7ABC BAYHAM STREET CAMDEN LIFESTYLE

SECTION 73 PROPOSED SCHEME AMENDMENTS
PLANNING APPLICATION
NOVEMBER 2020

This document has been prepared to present the amendments to the consented scheme (Ref: 2018/3647/P) which are predominantly internal and designed to suit the hotel brand.

FOURTH FLOOR

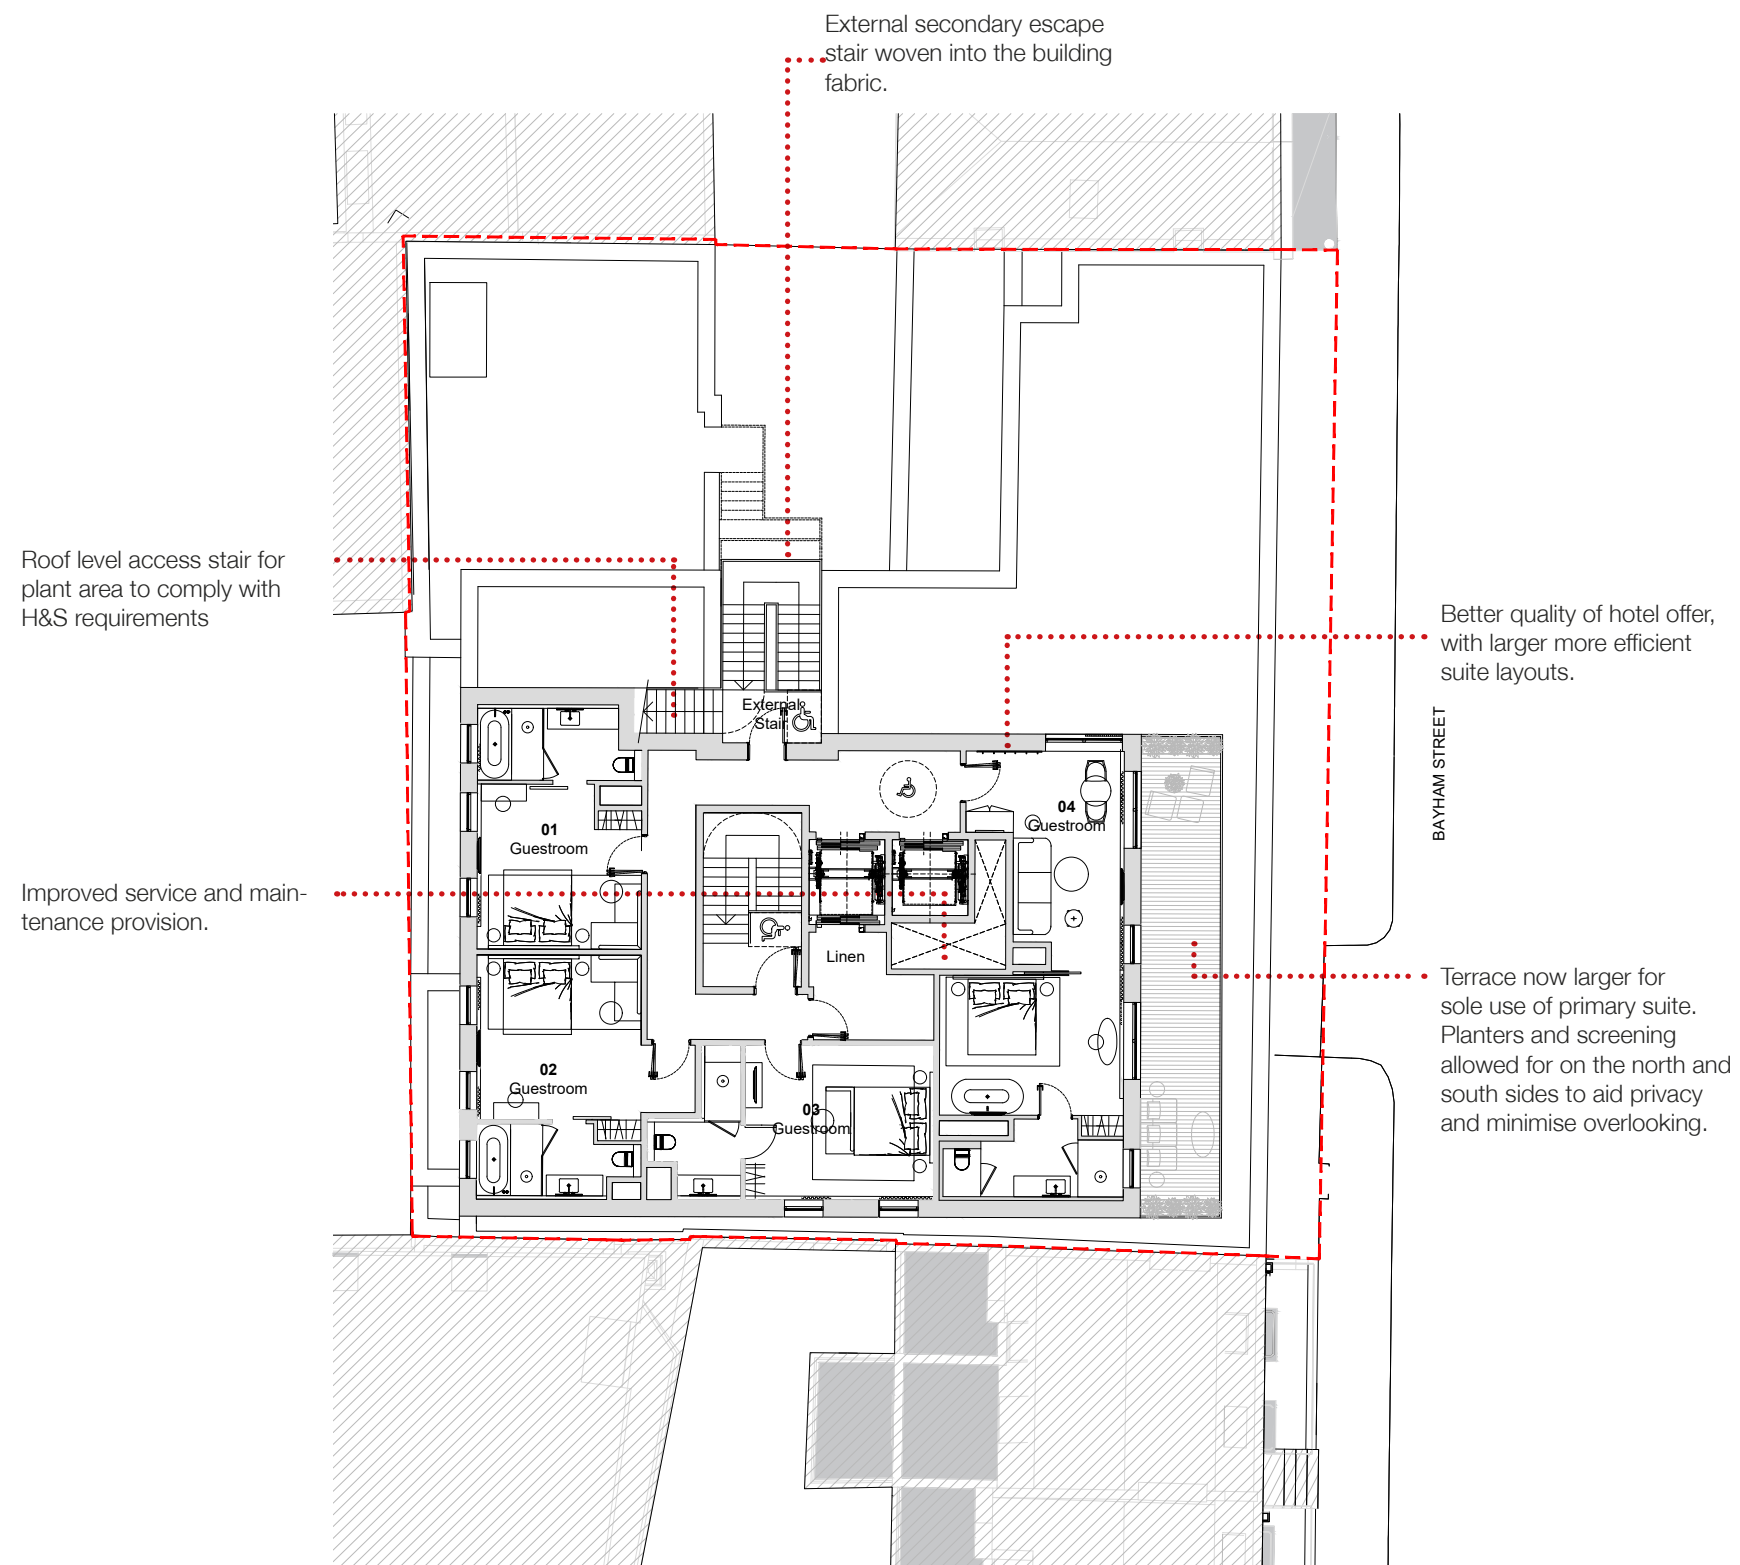
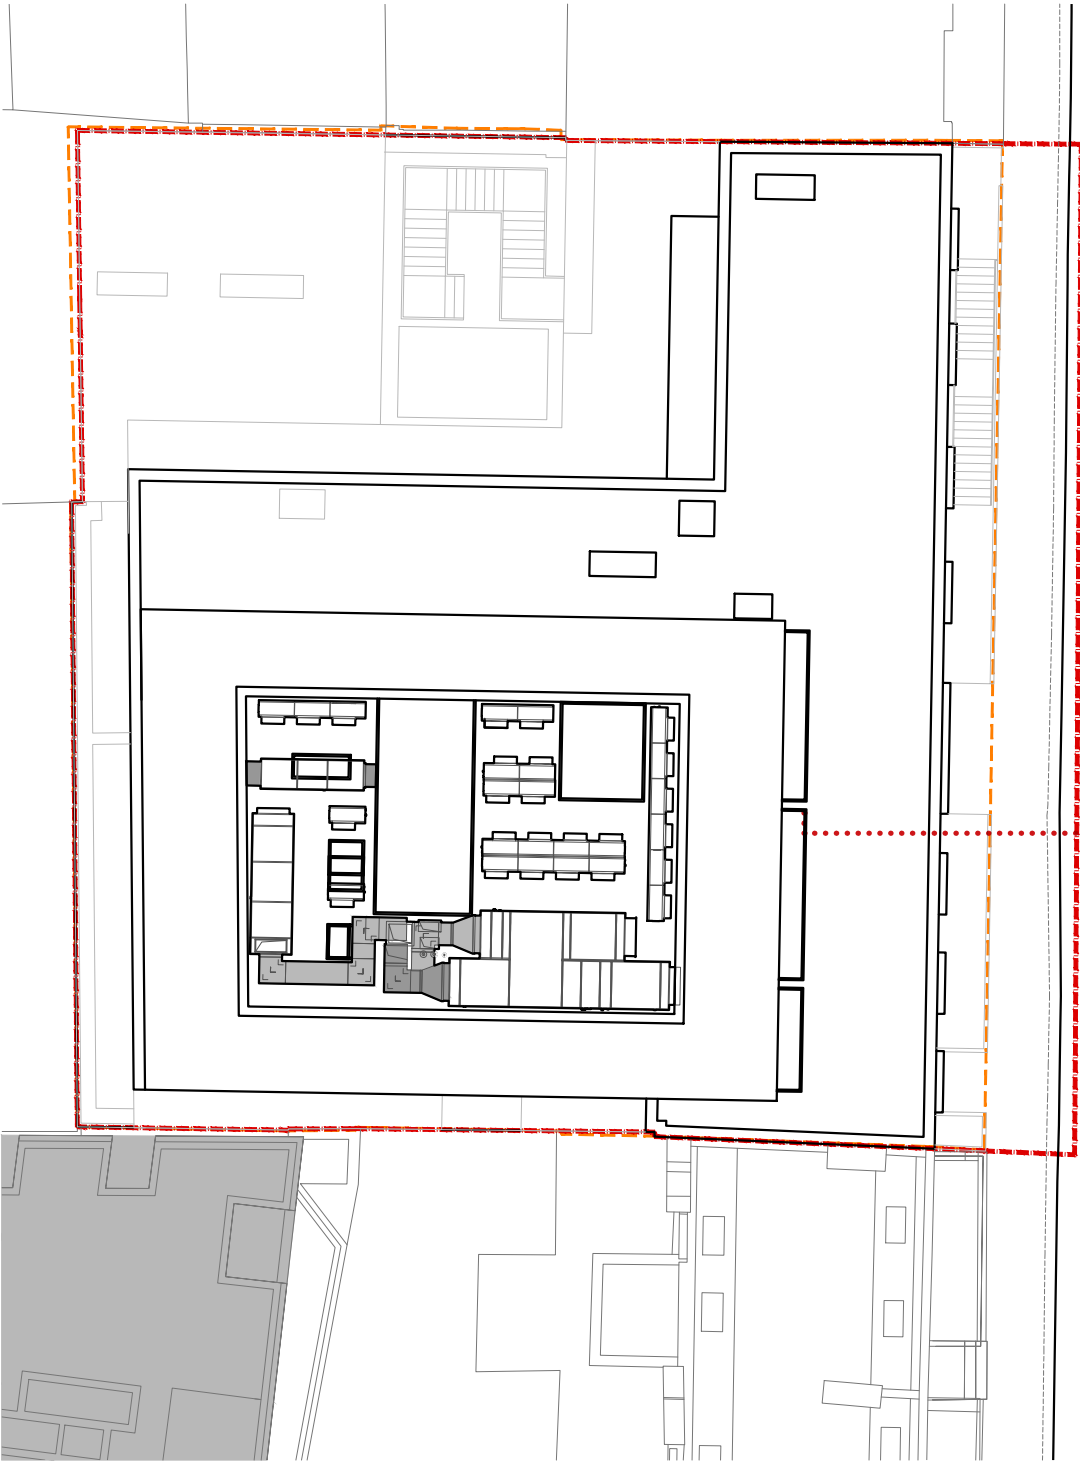
- Fourth floor revised to allow for high quality suites to align with clientele expectations.
- One large suite added fronting Bayham Street with private external roof terrace.

ROOF PROPOSED

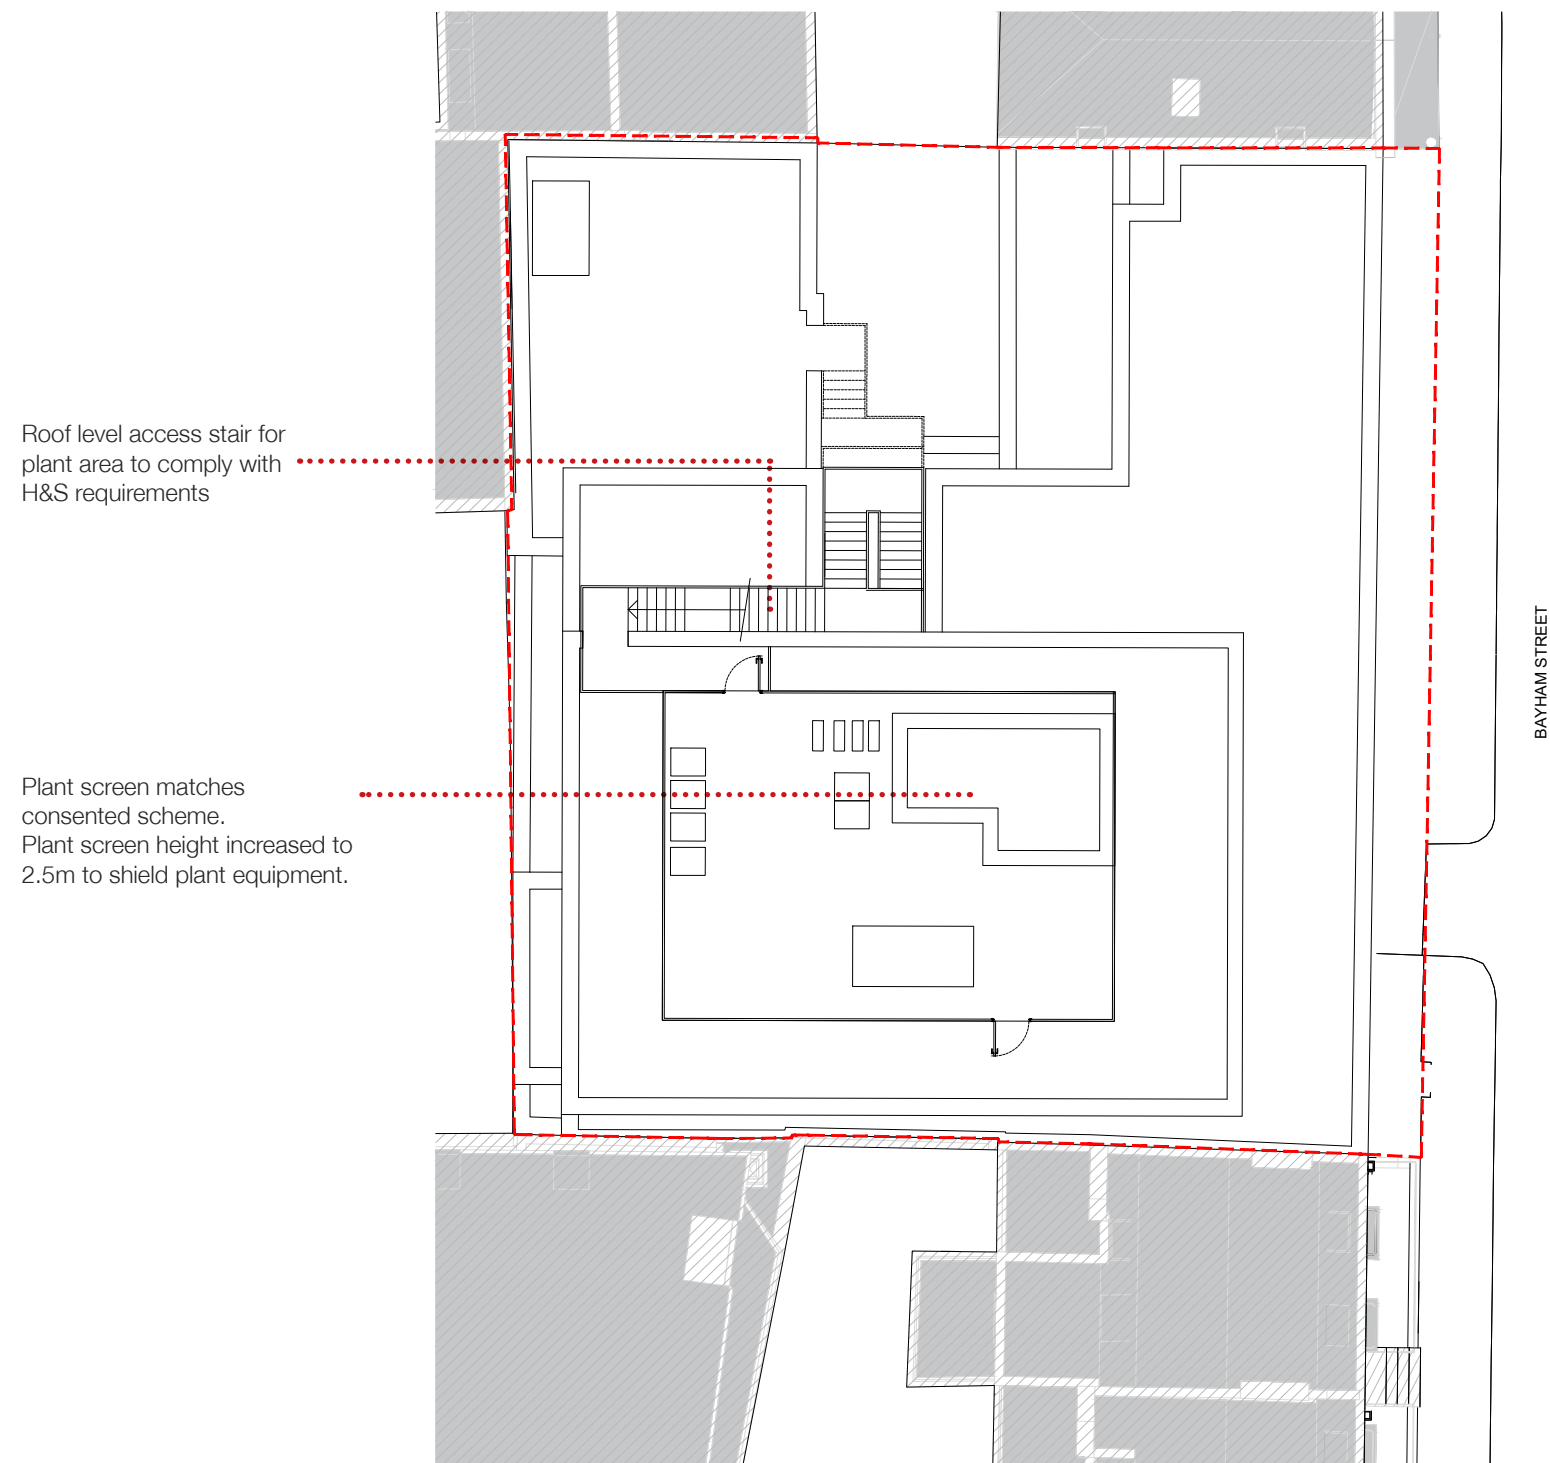
Limited access to roof plant area.

- Plant screen height increased to allow for adequate screening.
- The consented scheme allowed for minimal MEP plant at roof level and access for routine maintenance was not included. H&S guidance states that 3 points of contact should be available for employees accessing plant.
- Employees carrying tools and climbing ladders is not accepted. Further guidance on adequate plant space access for workmen with tools can be provided by the Principle Designer.

EAST ELEVATION

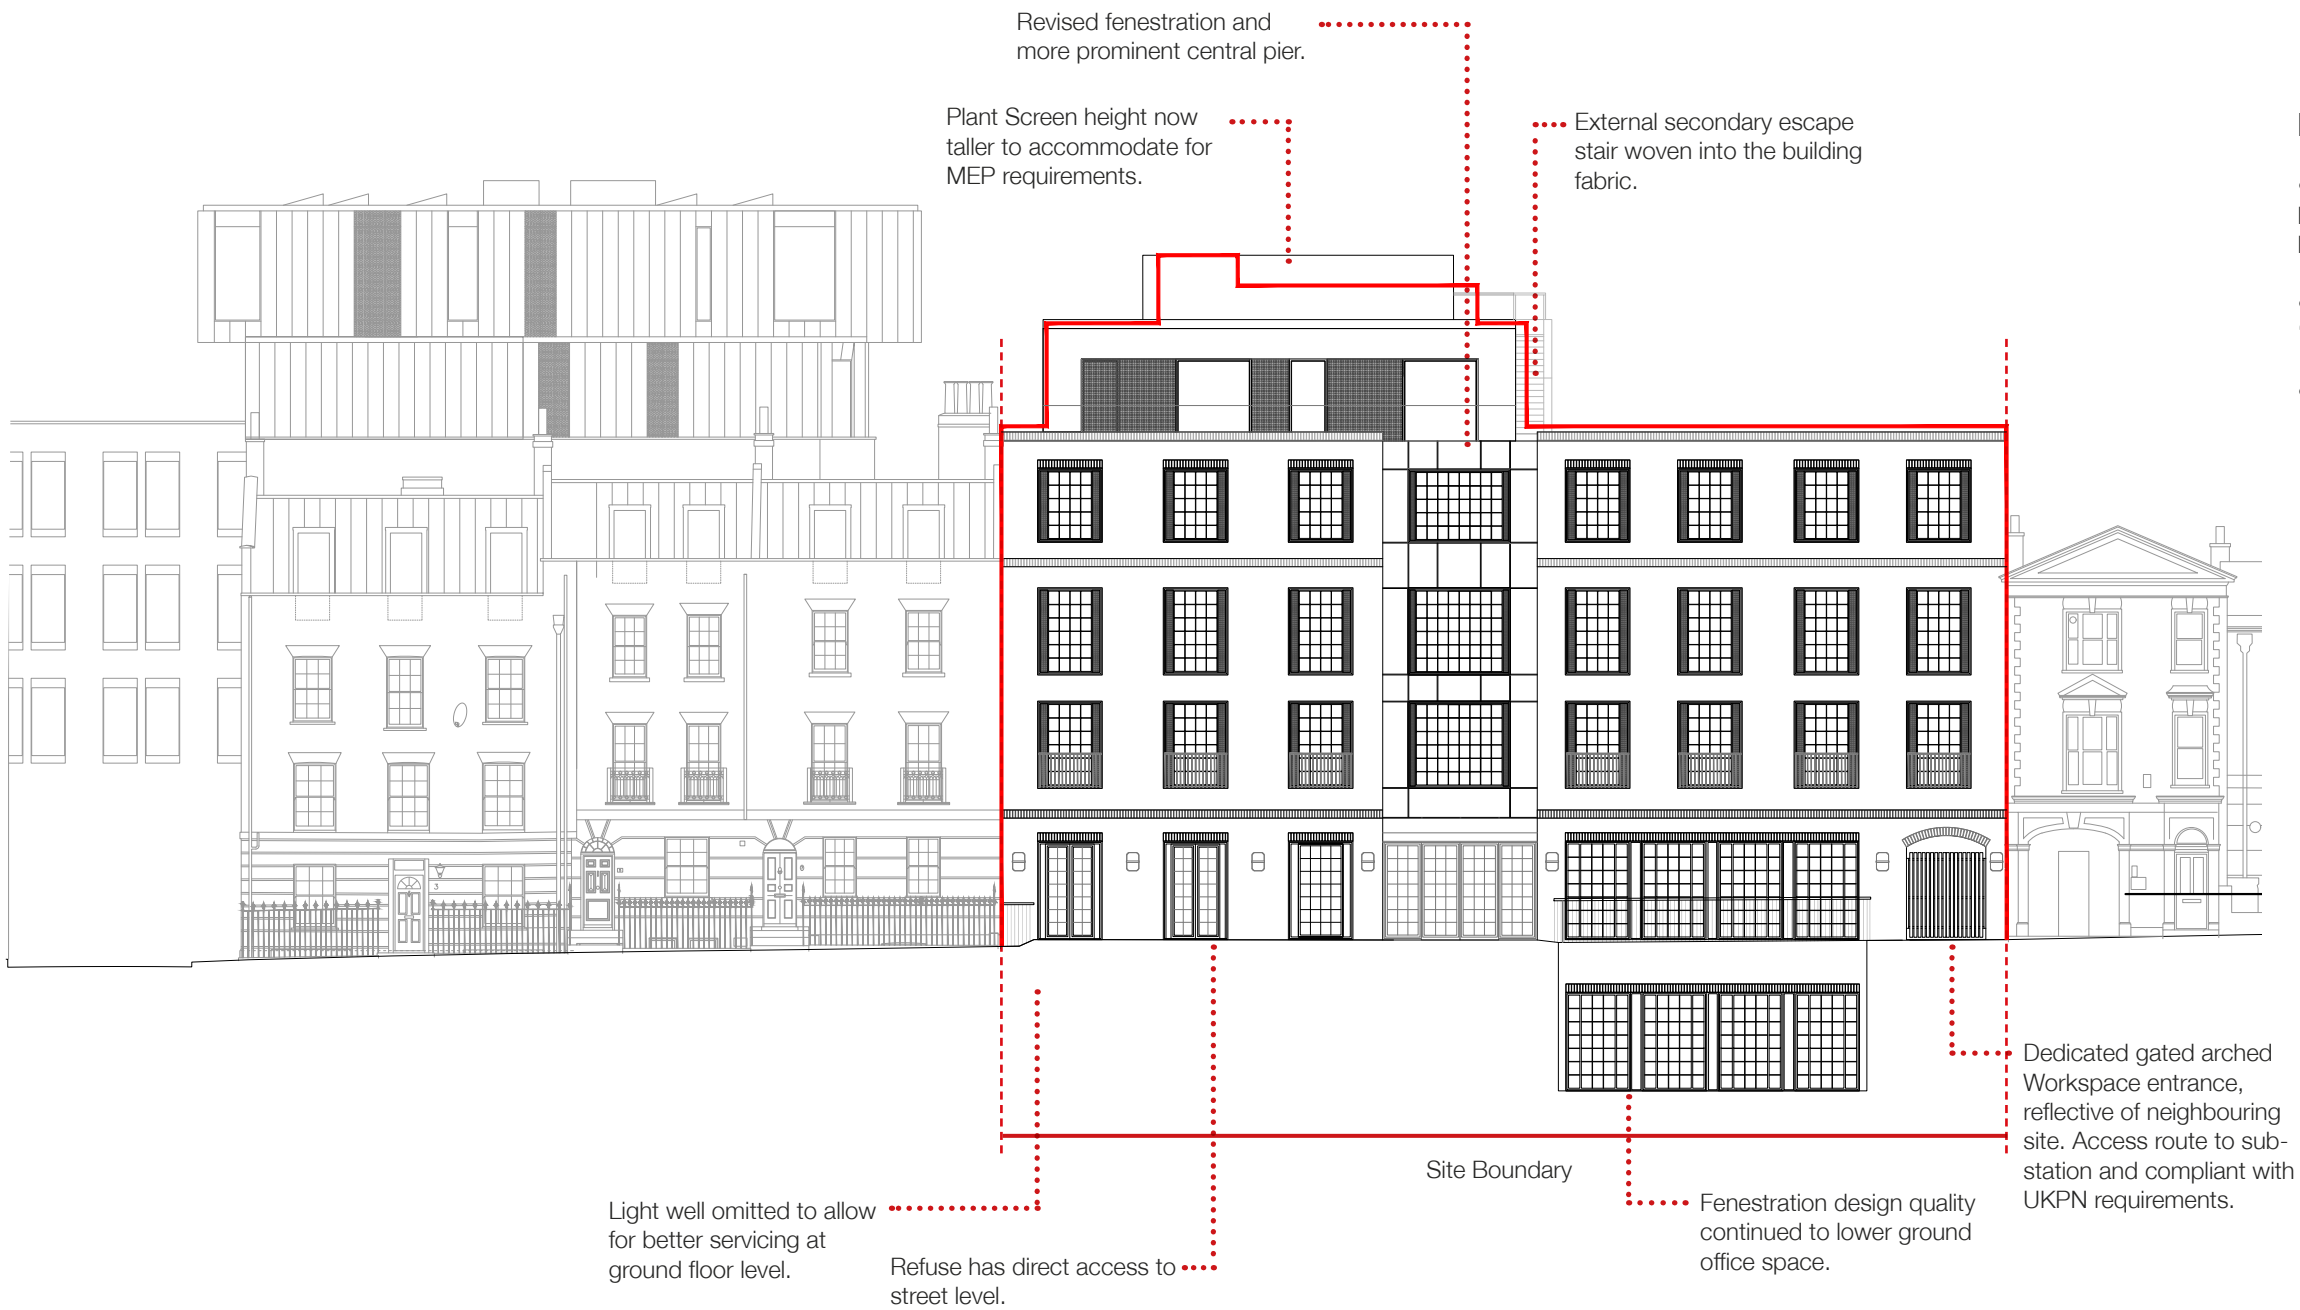
Consented scheme
lightwells create a difficult
relationship to neighbouring
buildings on Bayham St.

Consented access stair acts
as potential security risk

- The main facade has been revised to reflect the new internal layouts and also the Camden context, whilst adhering the key design language of the previously consented scheme.
- Window proportions and locations revised to align better with a 'warehouse' aesthetic.
- Materiality aligns with existing planning consent.
